UNITED STATES PATENT AND TRADEMARK OFFICE

APPLICATION NO.	FILING DATE	FIRST NAMED INVENTOR	ATTORNEY DOCKET NO.	CONFIRMATION NO.
10/693,699	10/27/2003	Farid Bruce Khalili	Ve 010	2292

Office Action Summary	Application No.	Applicant(s)	
	10/693,699	KHALILI, FARID BRUCE	
	Examiner	Art Unit	
	James L. Swiger	3733

DETAILED ACTION

FIG. 3

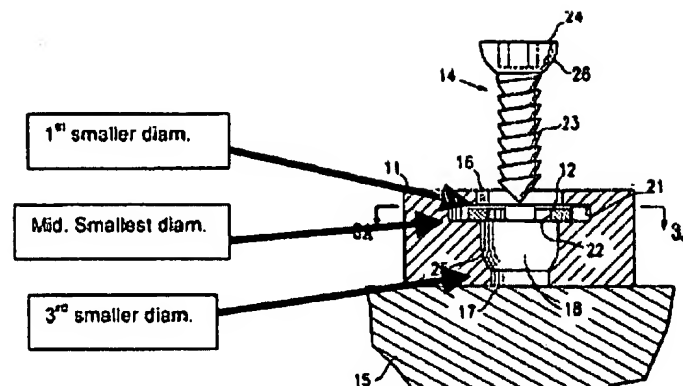
Claims 1-32 are rejected under 35 U.S.C. 102(b) as being anticipated by Talaber et al. (US Patent 6,261,291). Talaber et al. disclose an implant fastening/stabilizing system comprising a fastener (14) having a first and second ends and a shaft, the first end able to fixedly engage in a first body such as bone (15, see Fig. 1) and second end to a second body (such as 11) that may be implantable and spans between two bone structures (note split in Fig. 1), a resilient retention member (12) that is able to cooperate with the second body (see Fig. 3a) and that is considered a split ring that is capable of causing a fastener to move between a retained and non-retained condition because it is capable of producing a bias (Col. 4, lines 13-23) between either a relaxed or flexed state. The fastener comprises screw threads (see Fig. 2). The second end of the fastener, or at least a fastener retention system, is also considered to be a locking portion that has a larger diameter section (21) that fits between two smaller diameter sections. See drawing below with emphasis.

Within the large diameter section, the split ring may be positioned, through which it must be passed by a fastener in order to be removed. Depending on how it is viewed, the split ring may be fitted into a smaller diameter setting, if it is appropriately adjusted, where it could also be positioned, as a functional limitation, around a smaller diameter setting. The larger diameter in the second body, is also considered to be subsurface and the split ring has a greater outer diameter in its relaxed state compared to the surface diameter, which is being considered as the "above smaller diameter."
